ARCHITECT'S SUPPLEMENTAL INSTRUCTIONS

PROJECT:	Lee Lofts III Historic Rehabilitation & New Apartments Salina, KS	Report No.	Three (3)
OWNER:	Overland Property Group Dan Maximuk 234 N. Santa Fe Ave, Suite A Salina, KS 67401	Date	March 12, 2026
CONTRACTOR:	MCP Group 3501 SW Fairlawn Rd. Topeka, KS 66614	Architect's Proj No.	22-3243
		Contract For:	General Construction Mechanical, Electrical

- 1) Contractor to make adjustments as needed and required per the modifications as indicated on attached drawings and in the below descriptions (In response to several items listed on RFIs #18, 20, 22 & 25):

A2.0

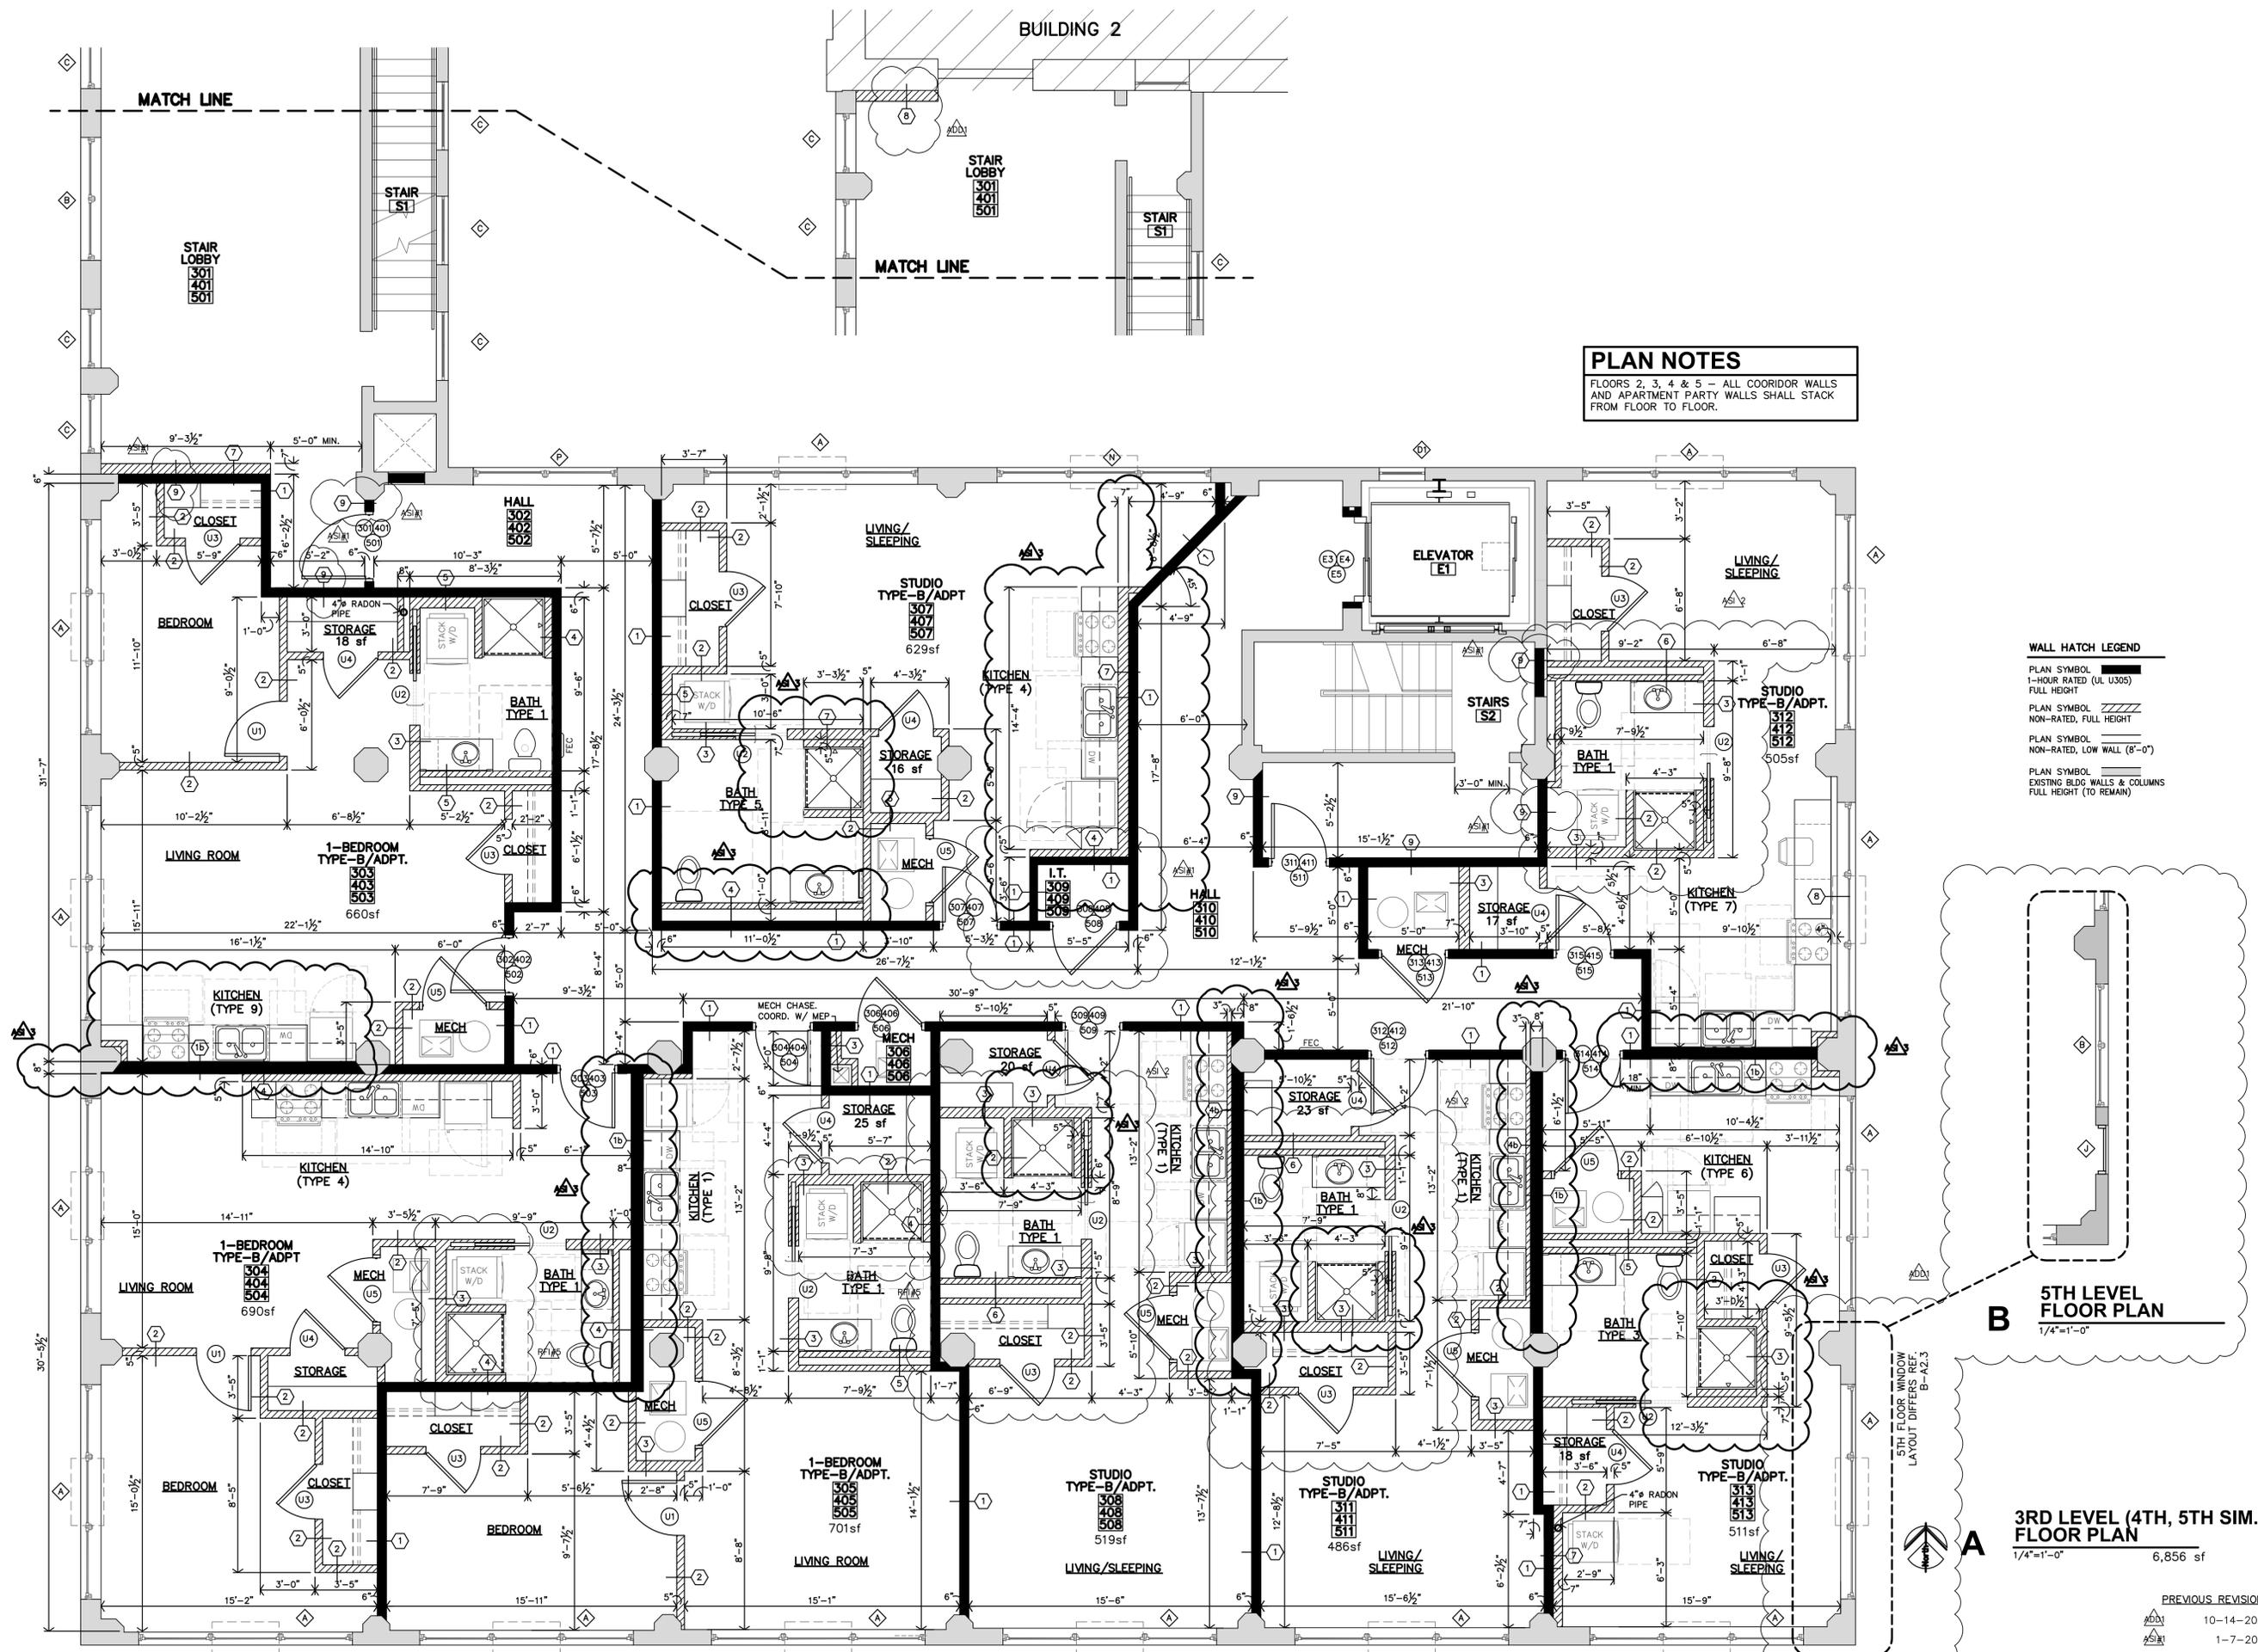
- c. Units 203, 303, 403 & 503 – increase party wall behind kitchen to type 1b (6" mtl. stud). Remove furred wall behind kitchen cabinets.
 - d. Unit 204 – Rotate toilet to the east wall and add a chase, similar to units above. Remove chase from south side of bath, except south of shower. Shift mechanical room and shower/vanity wall to the west 4".

- e. Units 205, 305, 405 & 505 – increase party wall behind kitchen to type 1b (6" mtl stud). Remove furred wall behind kitchen cabinets.
 - f. Units 207, 307, 407 & 507

- i. Furred wall has been added to the north side of the I.T. closet to accommodate the relocation of the elec. panel.
 - ii. Increase furred wall behind kitchen to type 7 (6" mtl stud).

- iii. Shift toilet/vanity wall north 3" to achieve 12" from face of bathroom wall to face of fire wall behind.
 - iv. Rotate shower, so that head is on north wall. Add 5" furred wall behind shower head.

- g. Units 208, 308, 408 & 508
 - i. Change wall behind shower to a type 3 ILO a type 2.
 - ii. Increase party wall behind kitchen to type 1b (6" mtl stud). Change furred wall behind kitchen to a type 4b ILO type 4.

- h. Units 211, 311, 411 & 511
 - i. Change wall behind shower to a type 3 ILO a type 2.
 - ii. Increase party wall behind kitchen to type 1b (6" mtl stud). Change furred wall behind kitchen to a type 4b ILO type 4.

- i. Units 212, 312, 412 & 512
 - i. Countertop Microwave and associated electrical has been added to kitchen.
 - ii. Increase party wall behind kitchen to type 1b (6" mtl stud). Remove furred wall behind kitchen.

- j. Units 213, 313, 413 & 513
 - i. Furred 5" wall added on south side of shower. Size of closet above has been reduced by 5".
 - ii. Increase party wall behind kitchen to type 1b (6" mtl stud). Remove furred wall behind kitchen.

E1.5

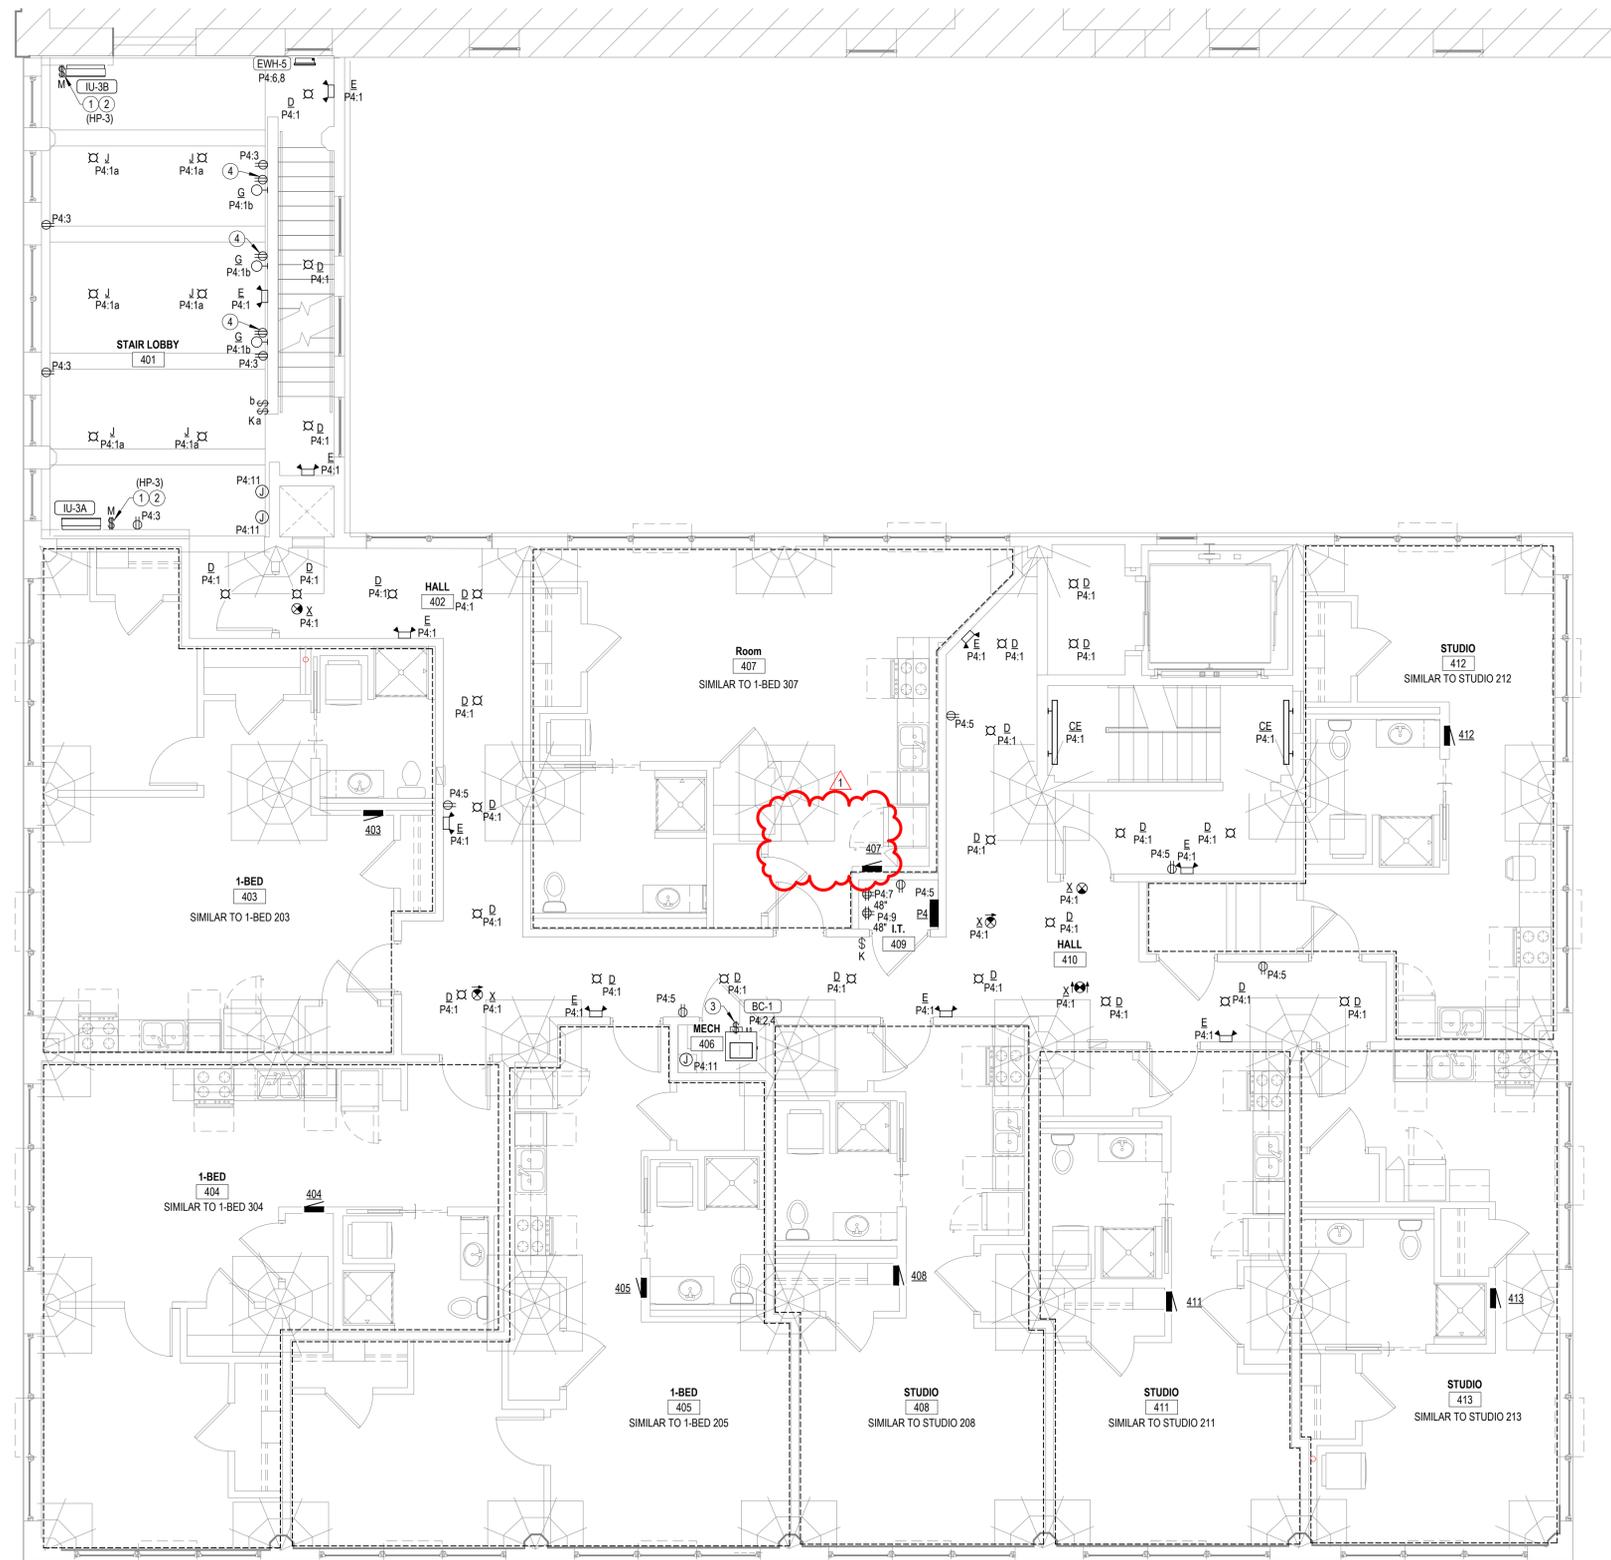
- k. MEP – Plumbing, Electrical and Mechanical modified to accommodate changes above.
